**AGENDA
CITY OF CREVE COEUR
PLANNING AND ZONING
300 NORTH NEW BALLAS RD
DECEMBER 19, 2022
6:00 PM**

- 1. PUBLIC HEARING Application #22-031: A Conditional Use Permit with Associated Site Development Plan for A New Chick Fil A Restaurant with Drive Through Services Located at 12398 Olive Boulevard**

**APPLICATION TO PLANNING AND ZONING COMMISSION
#22-031: A CONDITIONAL USE PERMIT WITH ASSOCIATED SITE
DEVELOPMENT PLAN FOR A NEW CHICK FIL A RESTAURANT WITH DRIVE
THROUGH SERVICES LOCATED AT 12398 OLIVE BOULEVARD**

Subject: Chick-fil-A TIS Review
Lochmueller Project #: 522-0072-01T

Figure 9: Applicant's Photometric Plan

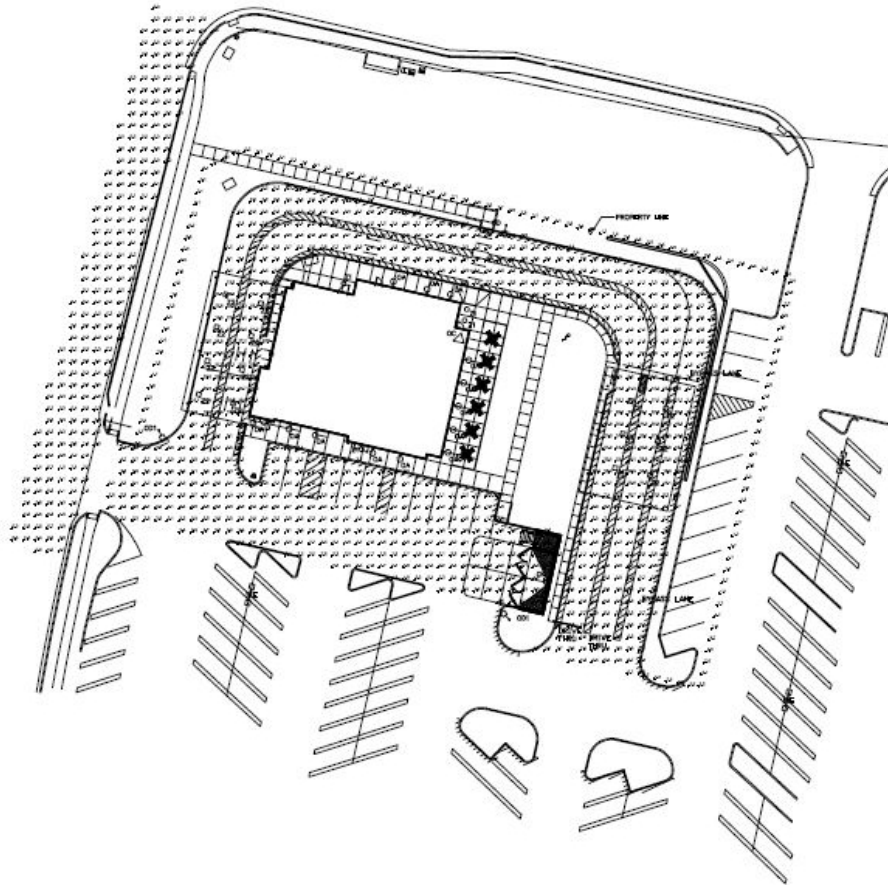
Due to the location of the project on a corner development site setback from Olive Boulevard, the likelihood for light spillage onto adjacent properties is not a concern but the light levels along Tempo Drive are considered. The submitted photometric plan shows that the light spillage onto Tempo Drive will be mostly less than 1 foot candle of illumination except at the Tempo entrance to the site where the illumination reaches 2 foot candles of illumination. The area of spillage is very minimal and does not extend very far onto the right of way. Staff is requesting this area be reevaluated in order to reduce the condition. A condition of approval has been added requiring the applicant to submit a final photometric plan. Lighting will be downcast and shielded in compliance with Section 405.680. The Applicant is proposing the use of LED flush mounted canopy luminaries for the canopy in a low-voltage option. The parking lot lighting is showing a mounting height of 27 feet, where Section 405.680(B)(3) has a maximum mounting height of 24 feet in non-residential districts. A condition of approval has been added to address the light pole heights. Section 405.680, Lighting, of the Zoning Code, and Section 205.810 of the Parking Ordinance requires a minimum of not less than an average of one (1) foot-candle of

illumination for a parking lot where the applicant is showing an average of 2.6 FC. The building lighting proposed is also shielded and will shine directly on the intended surface on site.

Figure 4: Proposed Landscape Plan

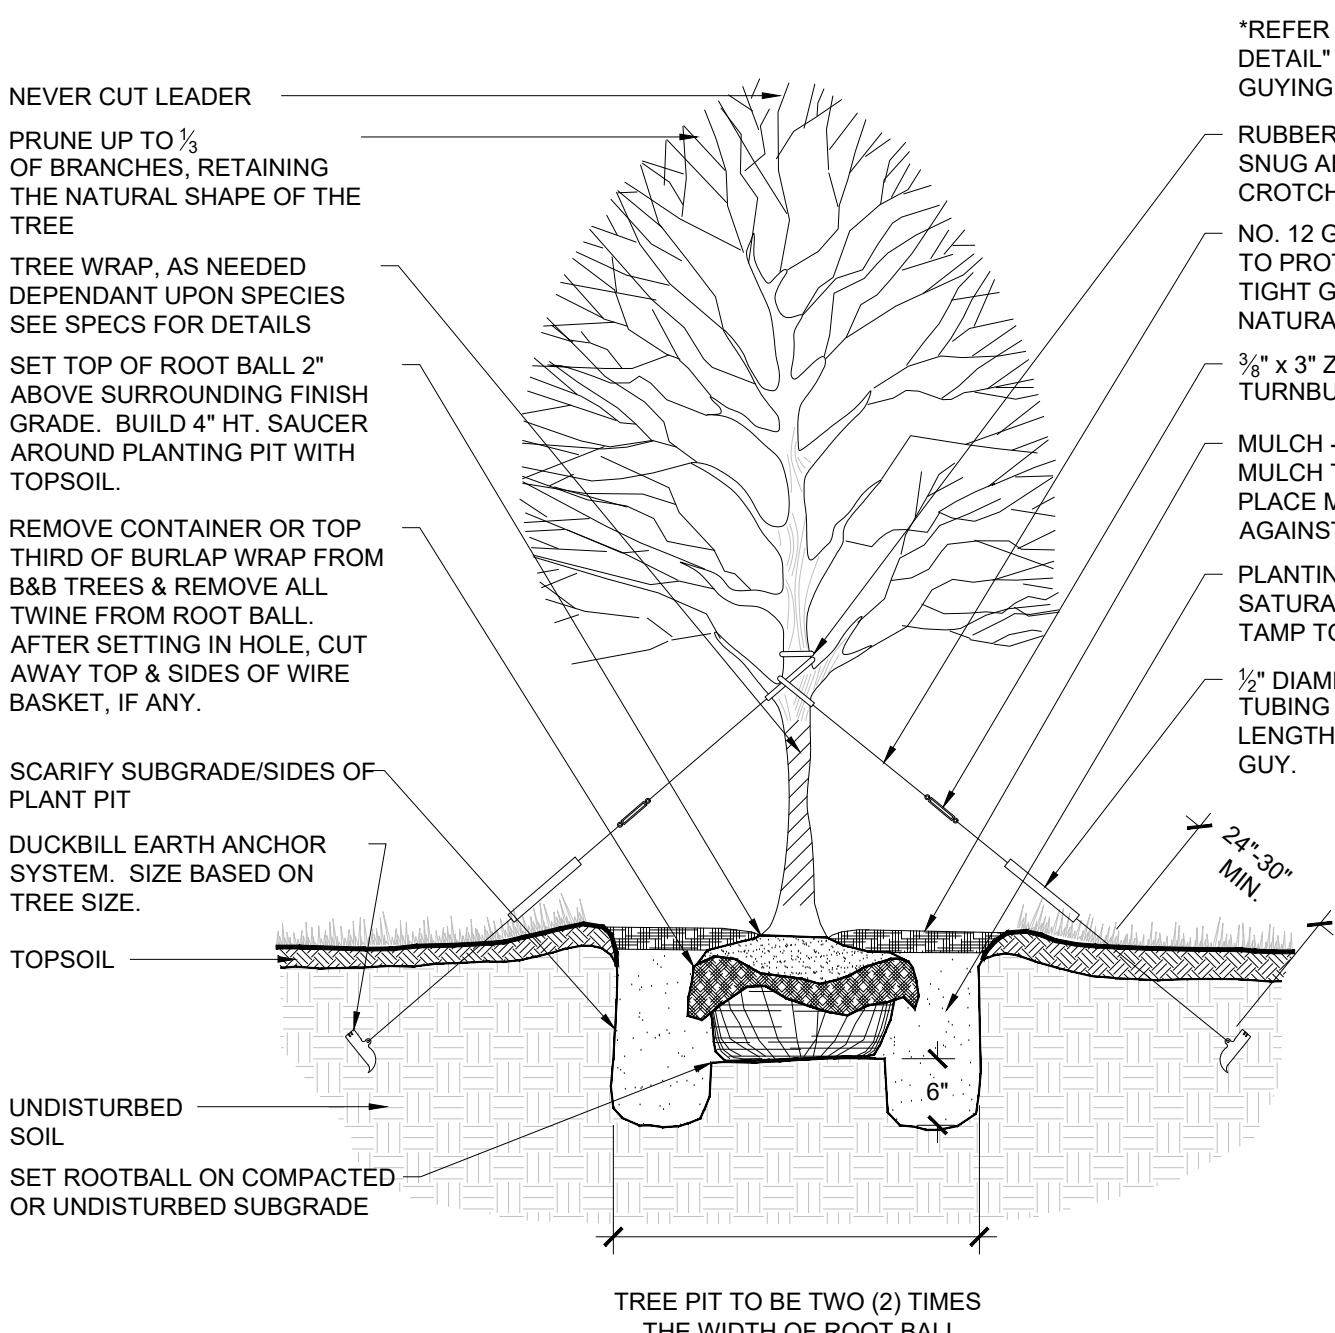
Overall, the Landscape plan shows significant landscaping throughout the site with a variety of plant materials and adequate screening of the parking lot and drive through services along Tempo Drive. As this project is part of the overall Westgate Centre, staff asked for new landscaping along Tempo Drive to buffer the parking lot and headlight glare from the road in order to fill in the existing bare areas. The proposed landscaping along Tempo is a mix of shrubs, evergreen shrubs, grasses and two Willow Oak trees to create a diverse buffer with more street trees per staff's request. An existing utility line prevented the installation of additional trees along Tempo Drive. The required amount of street trees for the proposed development area is 4 along Tempo Drive and 6 have been provided. A mix of evergreen shrubs and evergreen trees have been provided between Tempo Drive and the Chick-fil-a drive through pick up window in order to screen the service area from the road. The patio features a large landscaped area between the seating and the drive through lanes, a buffer of shrubs and upright evergreens around the columns of the canopy, and landscaping at the base of the building in order to provide a welcoming environment for diners. The trash enclosure is adequately screened with landscaping on all three sides and adequate landscaping is provided between the drive through lanes and the entrance lane to the shopping center from Olive Boulevard in form of fountain grass and shrubs. Two landscaping islands are provided in the existing parking lot to replace the landscaping islands that will be removed for the project and also serve to guide customers into the drive through lanes. Staff asked for one tree to be placed in each proposed drive through island in order to comply with the requirements of Section 405.540 (F)(4) and the applicant complied with Japanese Zelkova. Additional landscaping was provided in front of the building in order to screen the drive through lane in compliance with Section 405.470 which requires designated stacking lanes that pass between the building and the primary street frontage to be screened in the form of dense landscaping. The buffer features a mix of Eastern Redbud and Snowdrift Crabapple trees as well as shrubs, evergreen shrubs and grasses. Upon review of the proposed plant material, staff determined that the Firepower Heavenly Bamboo is listed as an invasive species by the Missouri Department of Conservation and should be removed from the landscape plan and replaced with a non-invasive evergreen shrub 3-4 feet in height. A final landscaping plan can be submitted along with the building permits to address these deficiencies.

Chick-fil-a is proposing that the stacking lanes wrap around the building between the building and the primary street frontage along Olive Boulevard due to the nature of drive through restaurants and the location of the leased space. Screening in the form of a variety of plant material to form a dense landscaping buffer has been provided and staff is mostly supportive of the proposed landscaping buffer with a few exceptions. Staff has requested that the invasive species proposed be removed from the plan and the replacement of additional evergreen shrubs to grow to 3-4 feet in height be provided. ***Criterion partially met subject to further revisions to the landscape plan.***

FIGURE 5 – DIRECTIONAL DISTRIBUTION

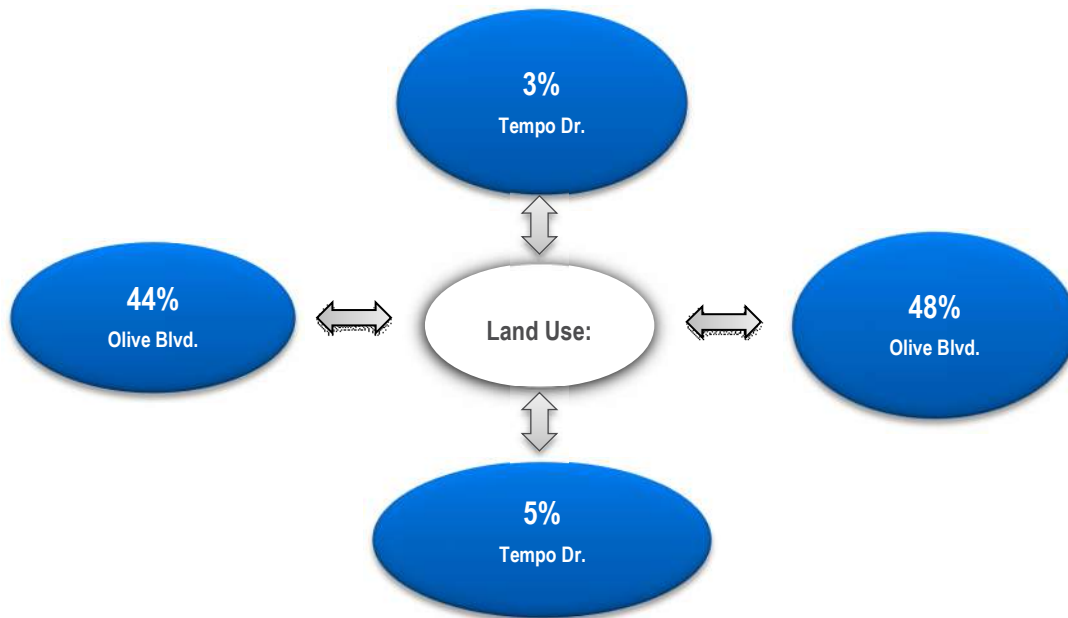
7. The directional distribution shown in **Figure 5** has 20% of traffic originating to/from Tempo Drive. However, the average over all four peak hours is only about 8%. It is our opinion that the 20% along Tempo Drive is too high.

8. The directional distribution shown in **Figure 5** has 20% of traffic originating to/from Tempo Drive. However, the average over all four peak hours is only about 8%. It is our opinion that the 20% along Tempo Drive is too high. Which could lead to a reduction in actual demand along Olive Boulevard which could impact the operations of the westbound left turn lane at Tempo Drive further.

8. The directional distribution shown in **Figure 5** has 20% of traffic originating to/from Tempo Drive. However, the average over all four peak hours is only about 8%. It is our opinion that the 20% along Tempo Drive is too high.

8. The directional distribution shown in **Figure 5** has 20% of traffic originating to/from Tempo Drive. However, the average over all four peak hours is only about 8%. It is our opinion that the 20% along Tempo Drive is too high. Which could lead to a reduction in actual demand along Olive Boulevard which could impact the operations of the westbound left turn lane at Tempo Drive further. **The analysis was revised based on this suggestion and the Synchro analysis re-done based on the new trip assignment and distribution.**

Figure 6
Site Generated Traffic Volumes

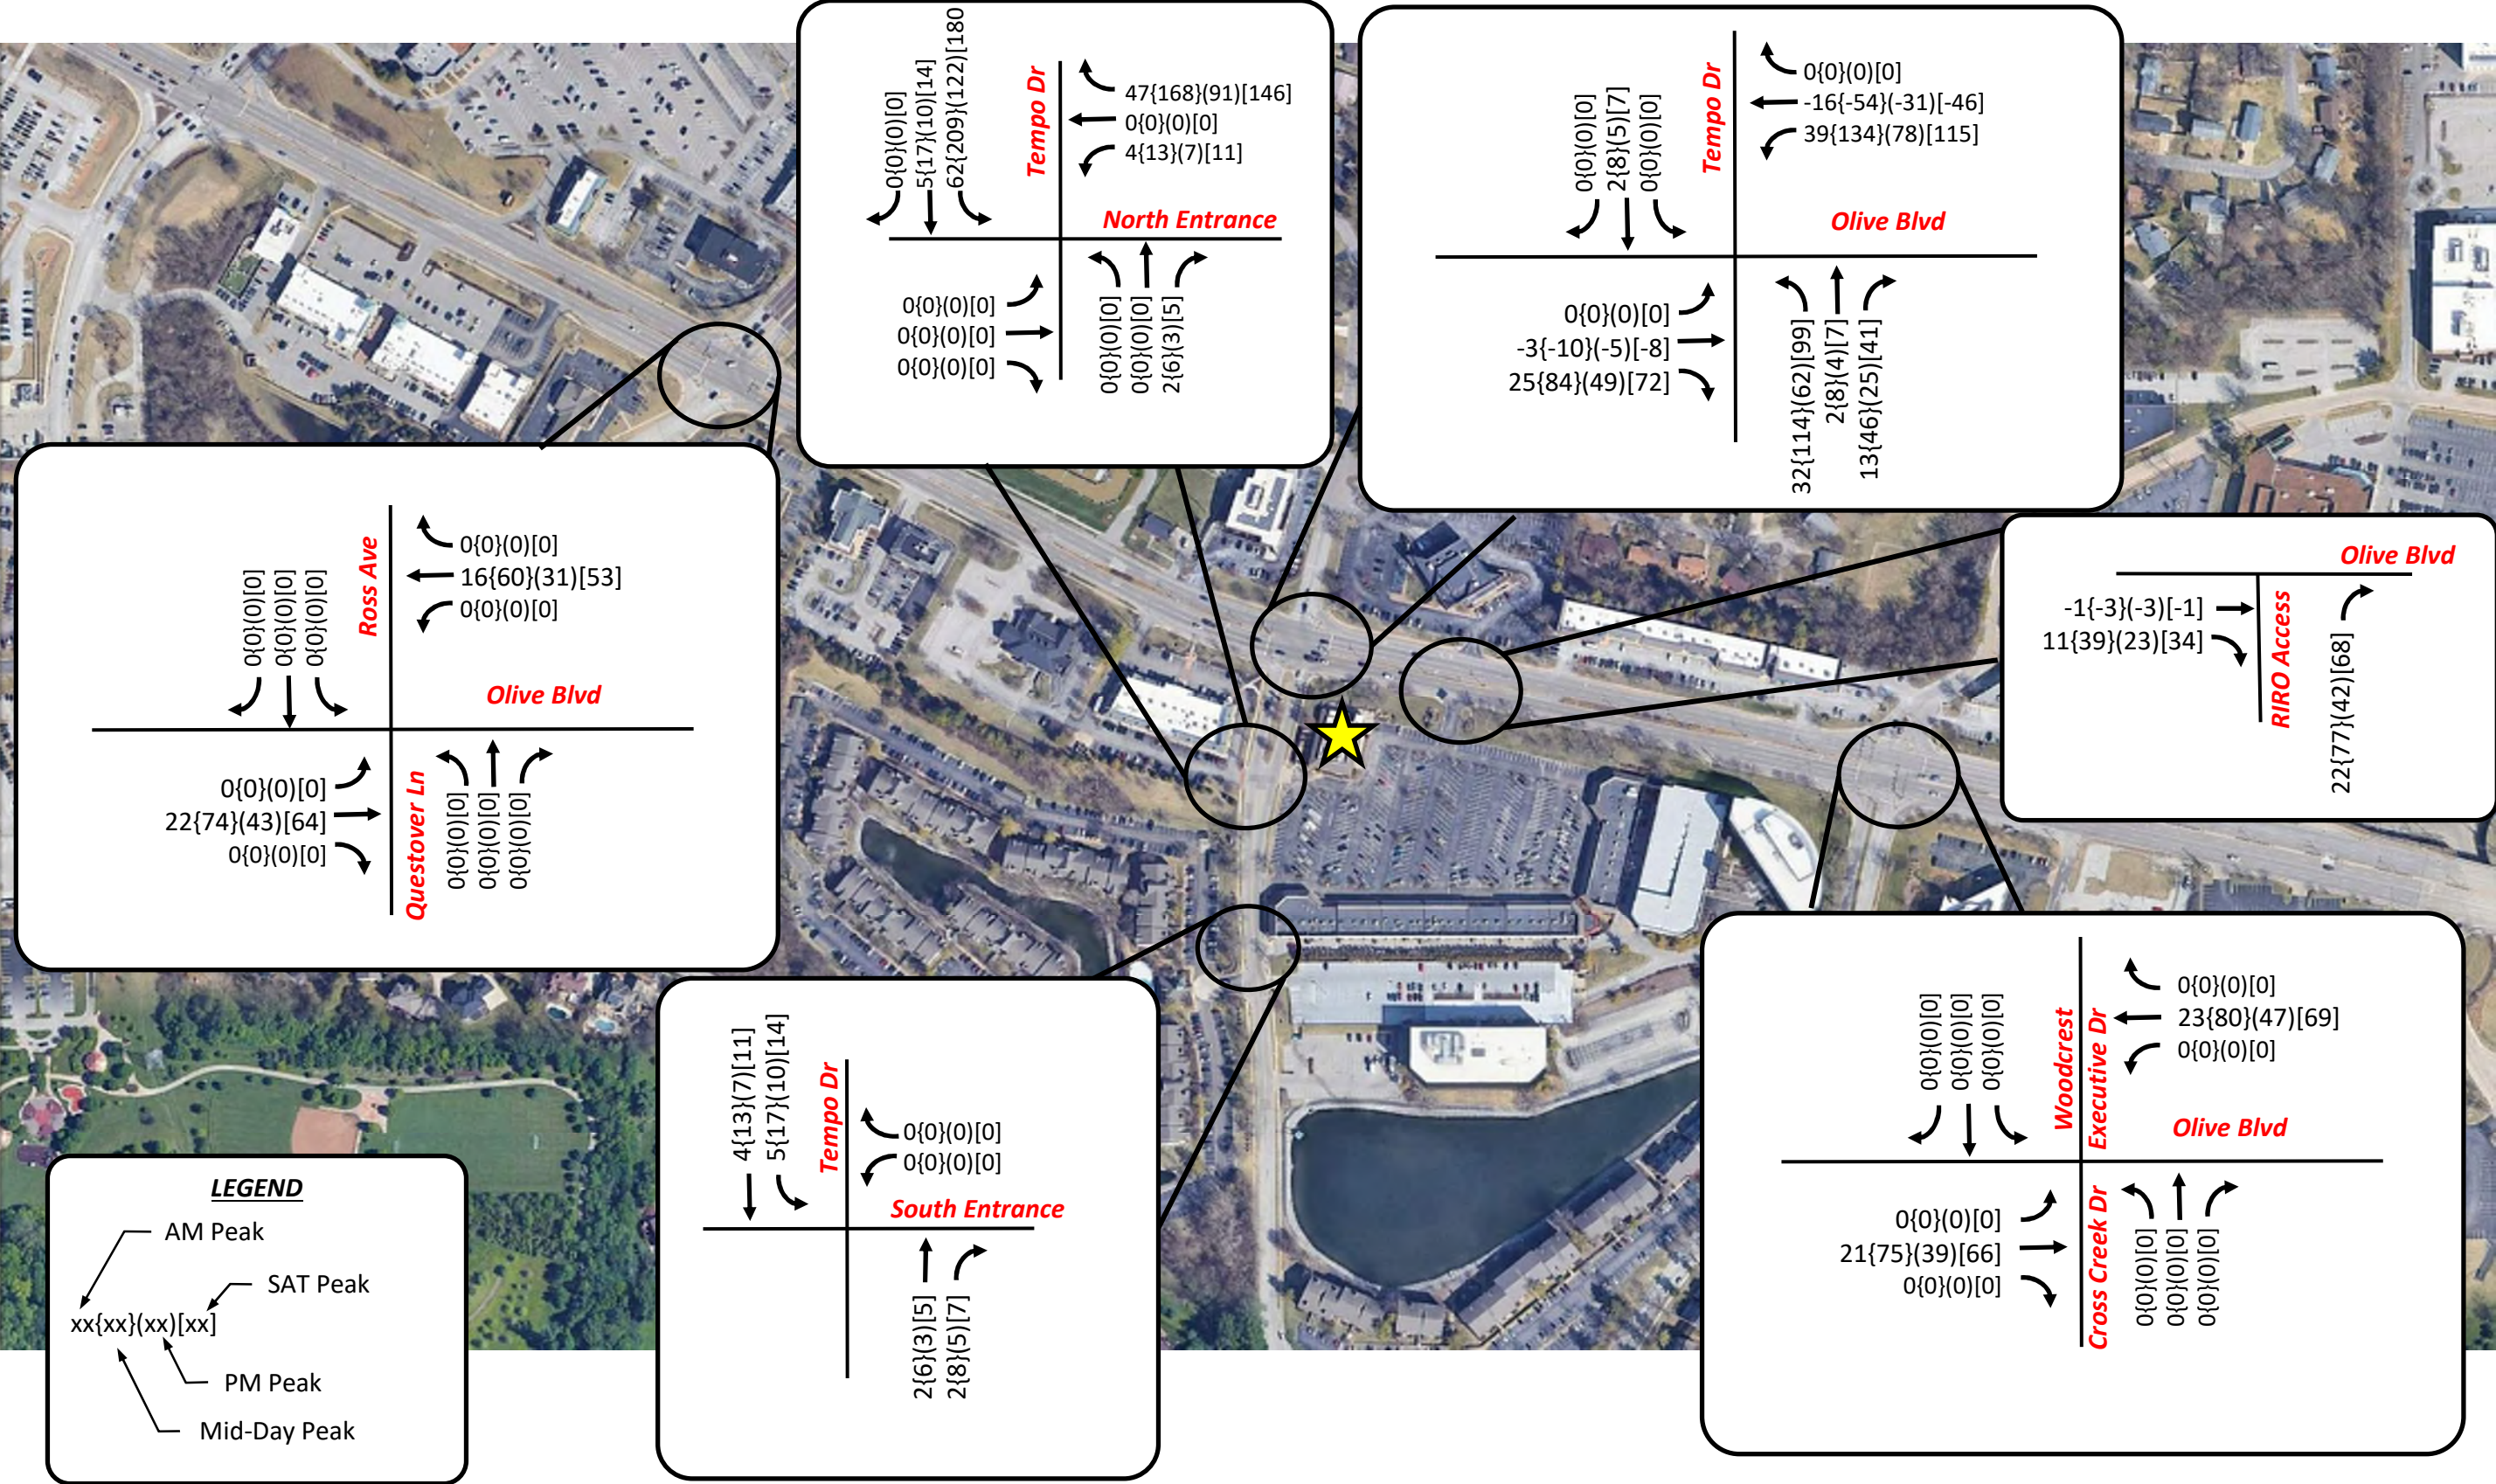
The site generated trips are shown in **Figure 6** of the report. The site generated trips do not add up in **Figure 6**. For example, at the intersection of Olive Boulevard and Tempo Drive there are 22 vehicles making an eastbound right-turn, 30 vehicles making a westbound left-turn, and 7 vehicles making a southbound through. This should equal 59 vehicles heading southbound at Tempo Drive and the North

Entrance; however, 66 vehicles are shown in **Figure 6**. It is recommended that this figure be revisited when applying the new directional distribution.

8. The site generated trips shown in **Figure 6** do not add up correctly based on the site generated trips provided in **Table 3** and the directional distribution shown in **Figure 5**.

9. The site generated trips shown in **Figure 6** do not add up correctly based on the site generated trips provided in **Table 3** and the directional distribution shown in **Figure 5**.

18. It is recommended that **Figure 6** be revisited and corrected when applying the new directional distribution.
19. It is recommended that the text on page 17 be revised to read 2045 rather than 2026.

4. It is recommended that **Figure 6** be revisited and corrected when applying the new directional distribution.
RESPONSE: Figure 6 has been updated.
5. It is recommended that the text on page 17 be revised to read 2045 rather than 2026.

9. The site generated trips shown in **Figure 6** do not add up correctly based on the site generated trips provided in **Table 3** and the directional distribution shown in **Figure 5**. **This item has been corrected in the revised documentation.**

18. It is recommended that **Figure 6** be revisited and corrected when applying the new directional distribution.
Figure 6 has been revised accordingly.
